**SUBJECT: Item Th23a for the August 2013 Meeting of the Coastal Commission
Appeal A-3-SCO-11-044 (Mike Pitt Project at 391 24th Avenue, Santa Cruz)**

SUBJECT: **REMOVAL OF EXISTING RETAINING WALLS**
391 24th Avenue, Santa Cruz, Santa Cruz County, California
APN 028-181-05

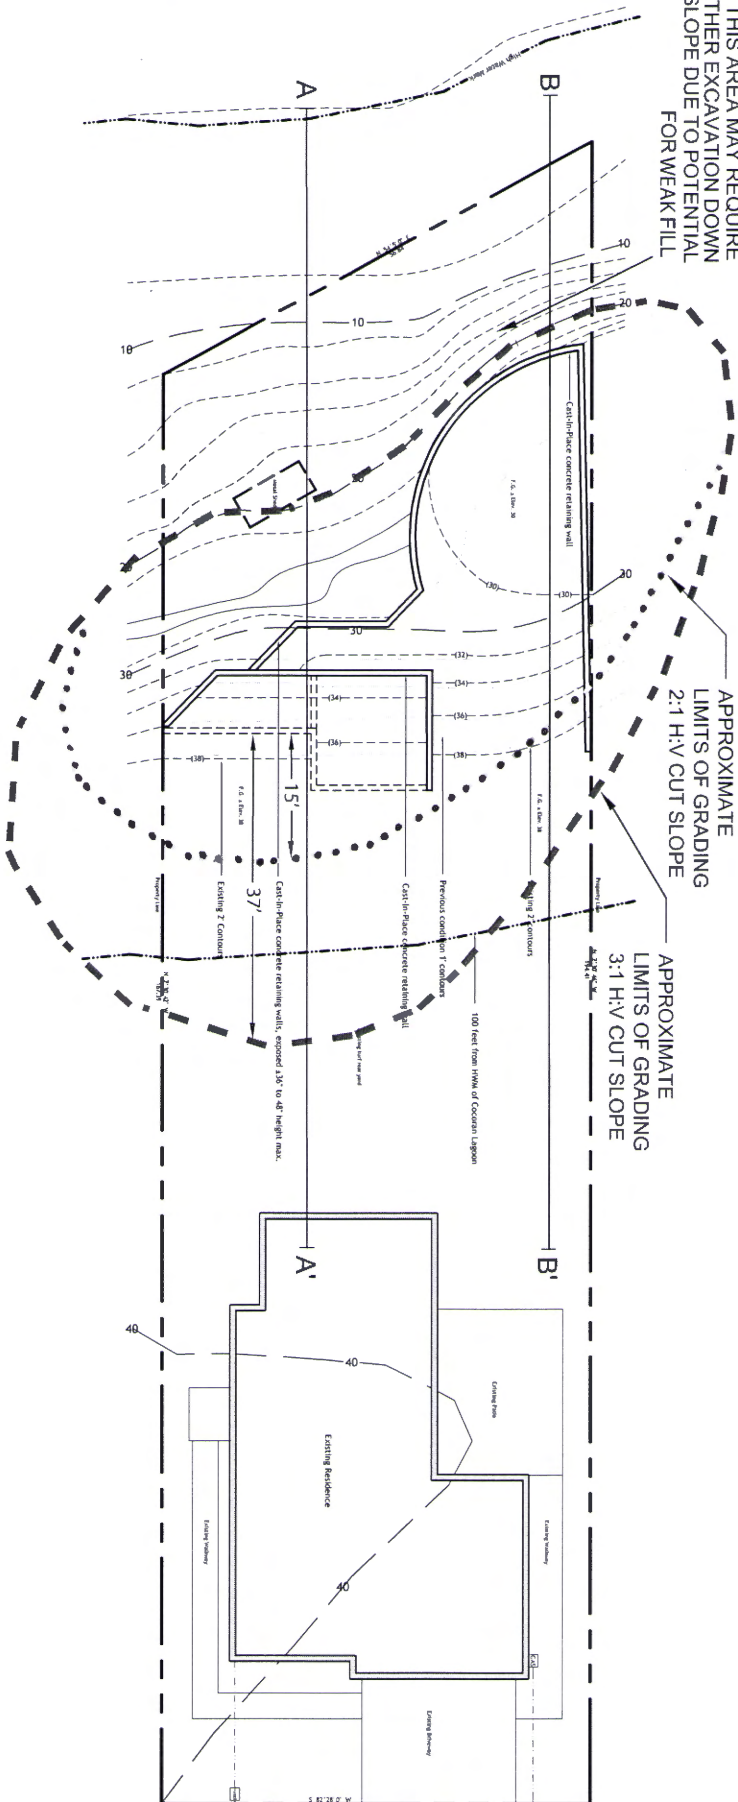
The approximate limits of grading due to the removal of the site retaining walls is depicted on Figure 1. The following statements have been prepared to summarize Figure 1.

- ▶ Based on our slope stability analysis, we have depicted the approximate limits of grading by constructing a 2:1 H:V cut slope. We have also outlined a scenario with a 3:1 H:V cut slope due to the unknown extent of the fill that was placed prior to Mike Pitt owning the property. The extent of the removed soil required to provide a stable slope configuration should be determined by the Geotechnical Engineer in the field during grading operations.

- ▶ Old fill may be encountered downslope of the curved wall, potentially requiring additional grading below the limits depicted on Figure 1 and additional grading on the property to the west.

Problem: 391 24th Avenue - FS Min-Bishop = 1.909

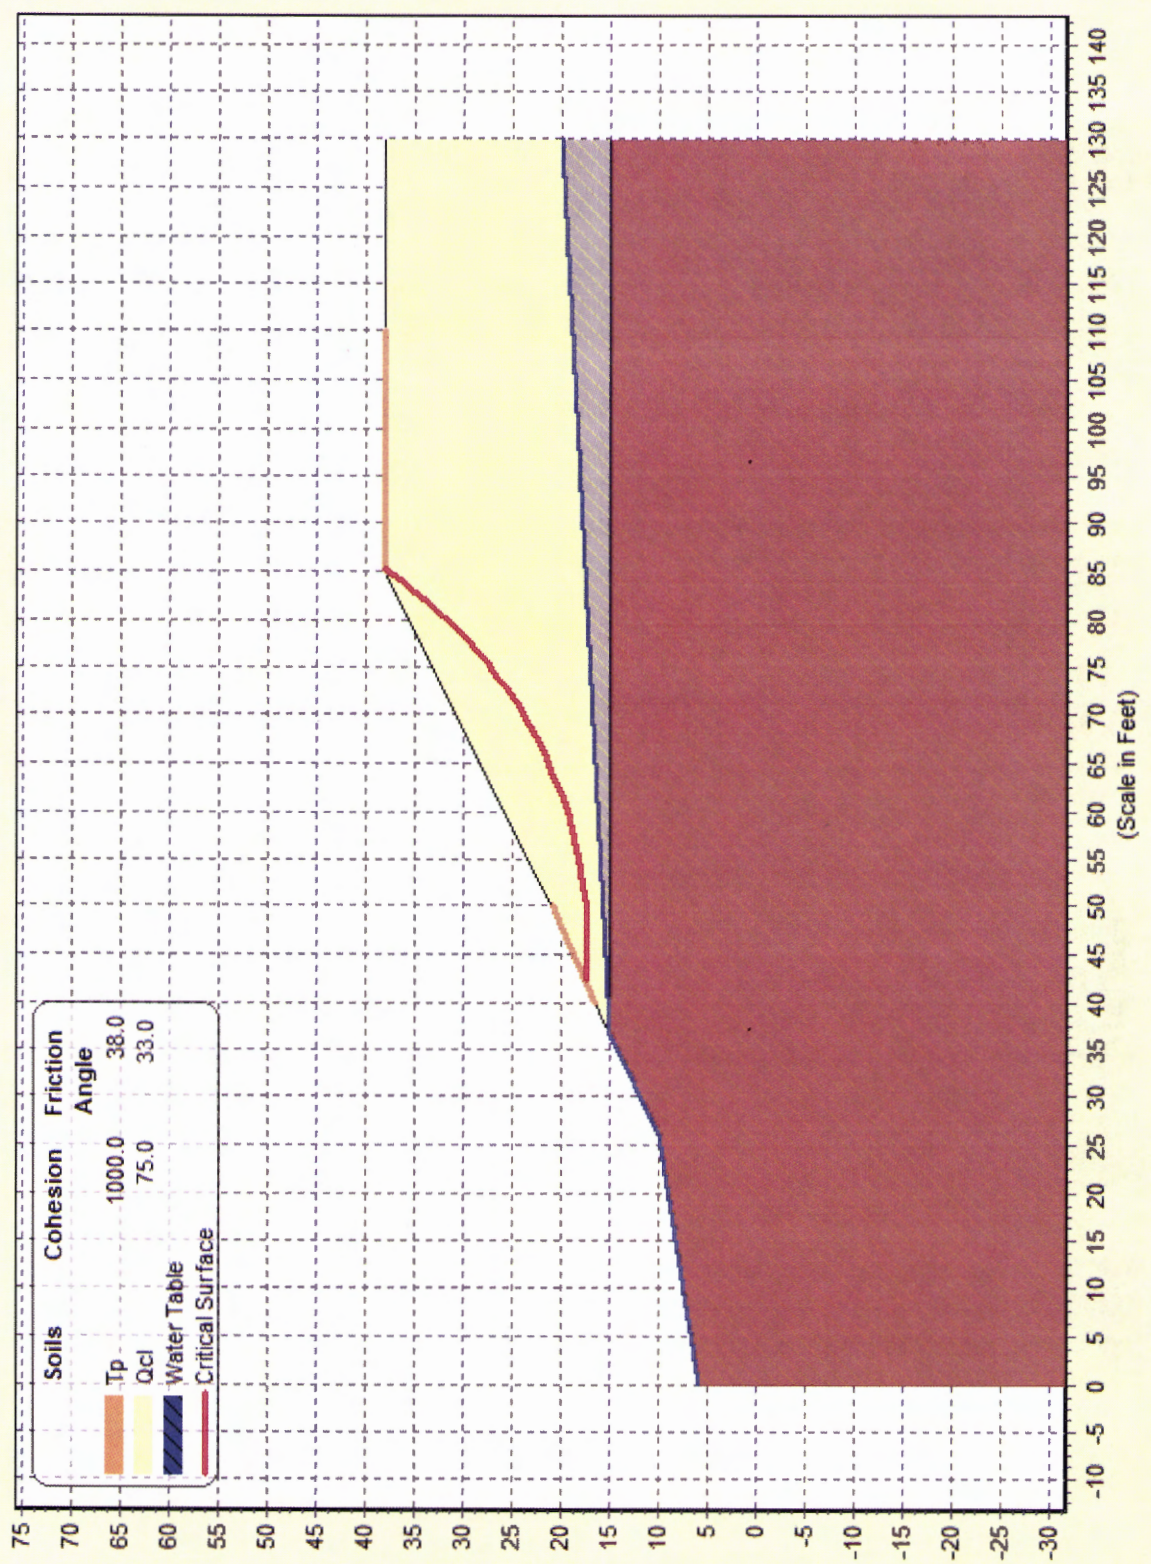
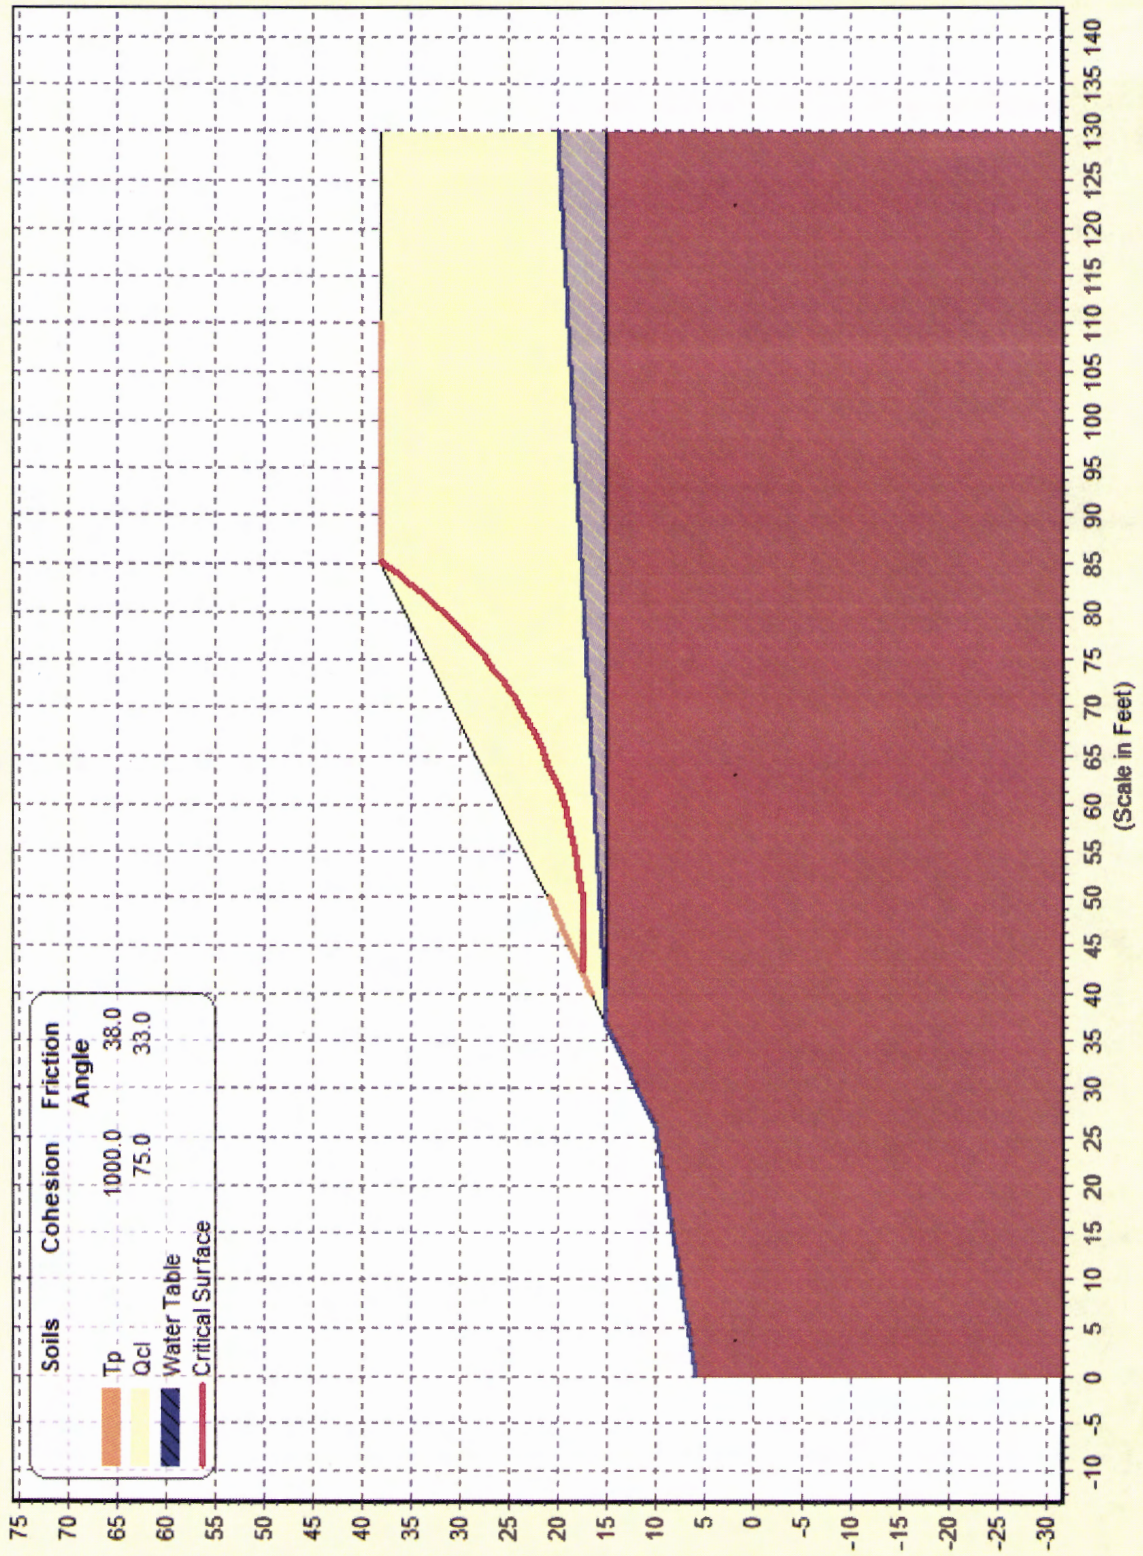
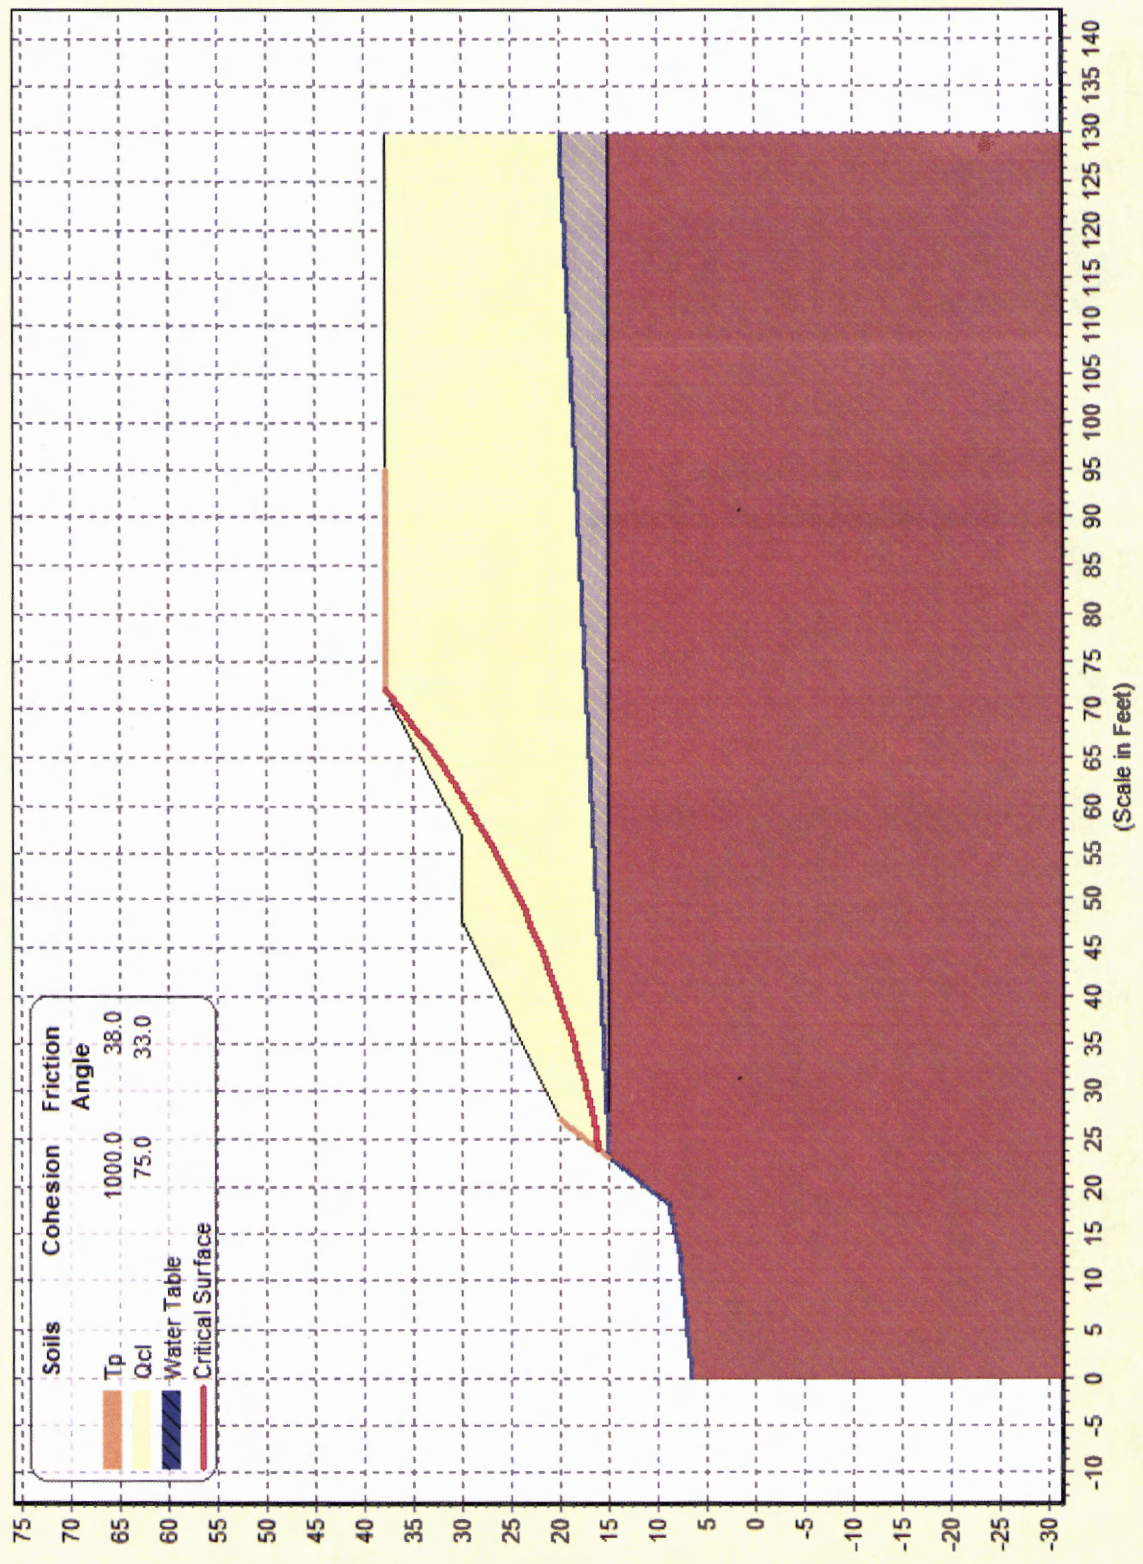
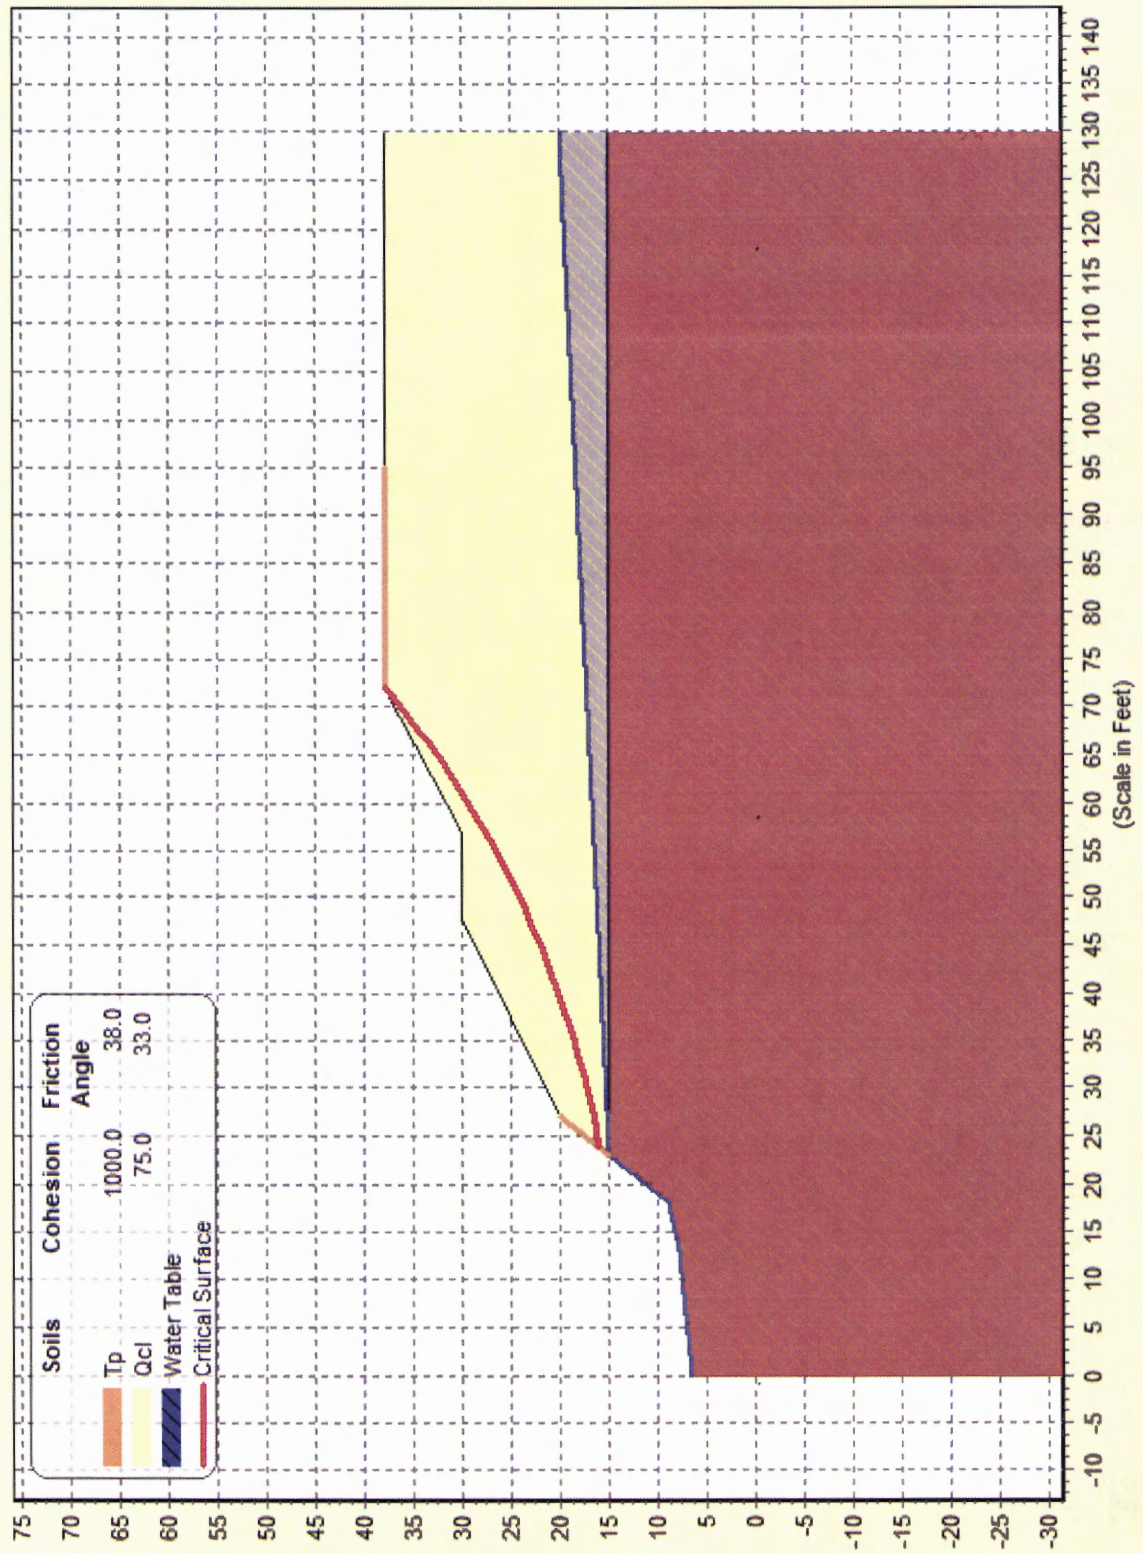
The staff report discusses a memo from Lesley Ewing (Exhibit 5 of report) which states the walls are not necessary to stabilize the slope. However, the analysis done by CMAC Engineering (Exhibit C) explains that removal of the walls will necessitate converting a substantial portion of level rear yard to an unusable slope on both Mr. Pitt's property *and* the rear yards of the adjoining properties to the east and west of Pitt. Figure 1 of Exhibit C shows the amount of land that must be removed in order to stabilize the slope without any walls. Approximately, 1,936 sq. ft. to 2,970 sq. ft.¹ of level land would be lost on Mr. Pitt's property, depending on the final slope configuration, and an additional area of possibly 1,000 sq. ft. of level/nearly level land would be lost on the two adjoining parcels.

Retaining Wall Segments the County Environmental Planning Agreed Should be Kept on the Site.

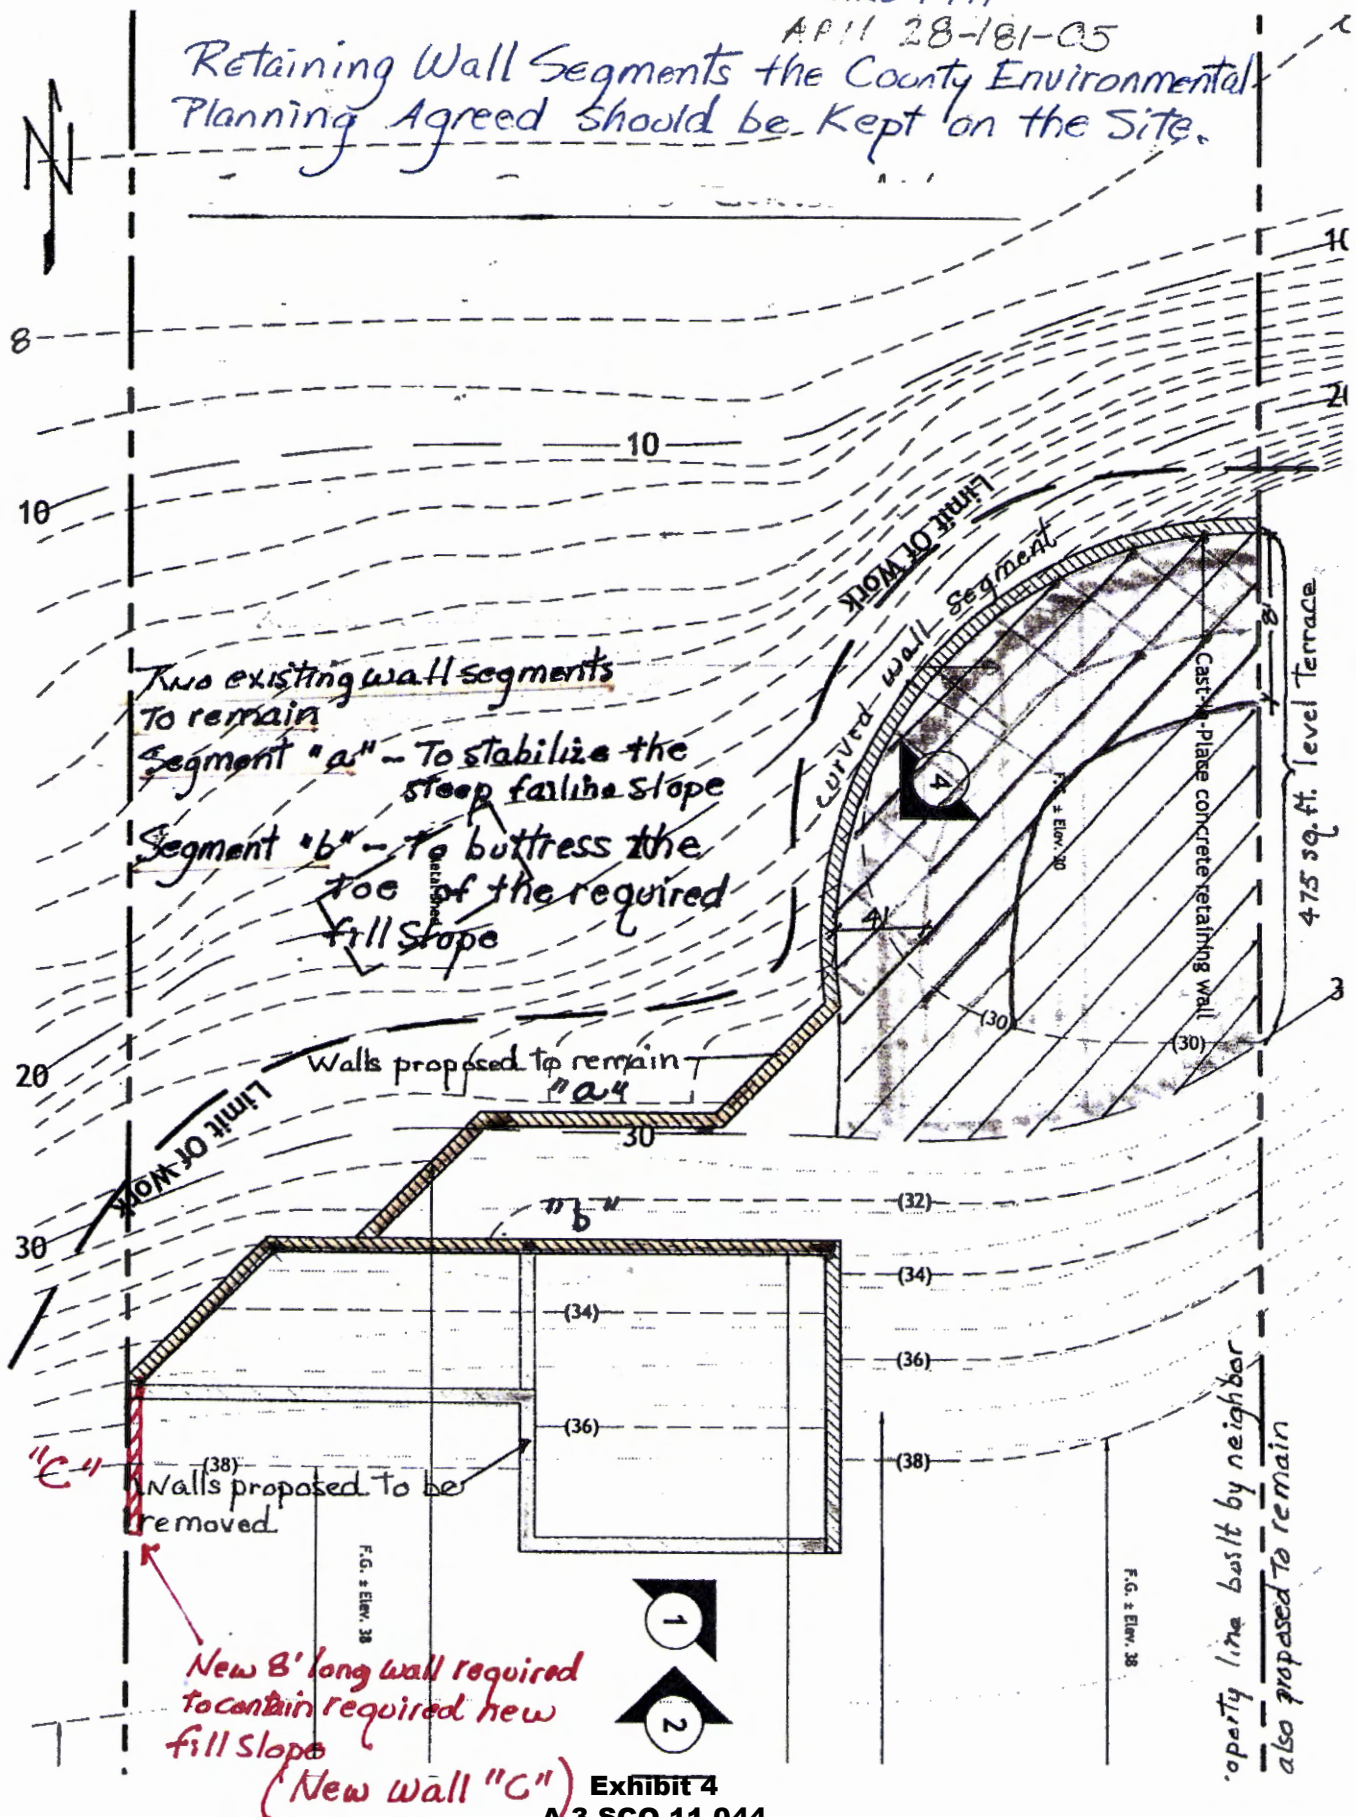
The existing retaining walls are described throughout the report as being located 35 feet from Corcoran Lagoon (e.g. page 5, paragraph 2, line 13). This is misleading. Only 1 foot of the curved wall is located 35 feet from the high watermark of the lagoon. The remainder of the curved wall and all other portions of the walls are more distant from the lagoon's edge. The wall described on page 5 as "a segmented angled wall" is actually two partially-parallel walls that are located 59 feet and 66 feet respectively from the lagoon high water mark. (Exhibit B).
